REMARKS

Amendments to the Drawings:

Attachment: Replacement Sheets

Annotated Sheets Showing Changes

Fig. 1

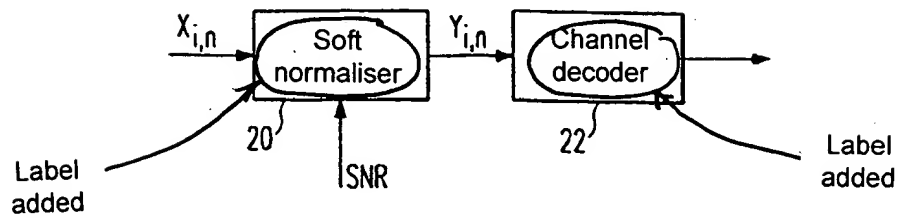
The first sheet, which includes Figures 1-3, replaces the original sheet including Figures 1-3. In Figure 1, elements 20 and 22 have been labeled as “soft normaliser” and “channel decoder”, respectively. In Figure 2, elements 24, 26, 28, and 34 have been labeled as “mean calculator”, “scaling factor”, “truncation”, and “round”, respectively.

Fig. 4
Prior art

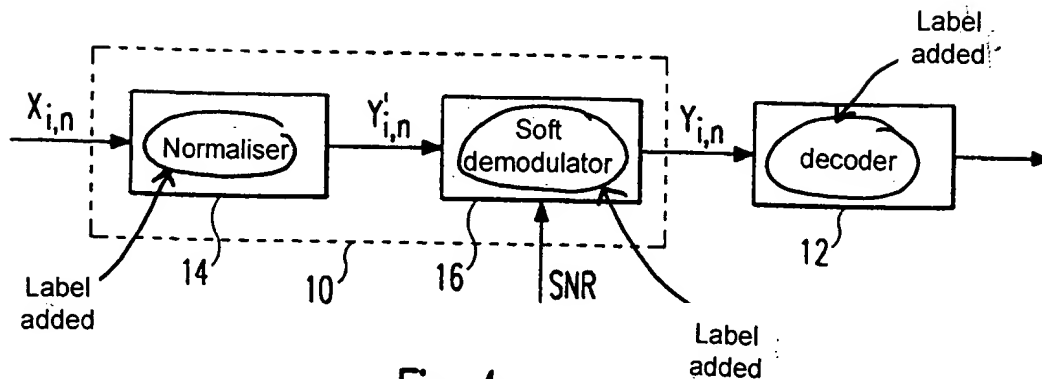
The second sheet, which includes Figure 4, replaces the original sheet including Figure 4. In Figure 4, elements 12, 14, and 16 have been labeled as “decoder”, “normaliser”, and “soft demodulator”, respectively.
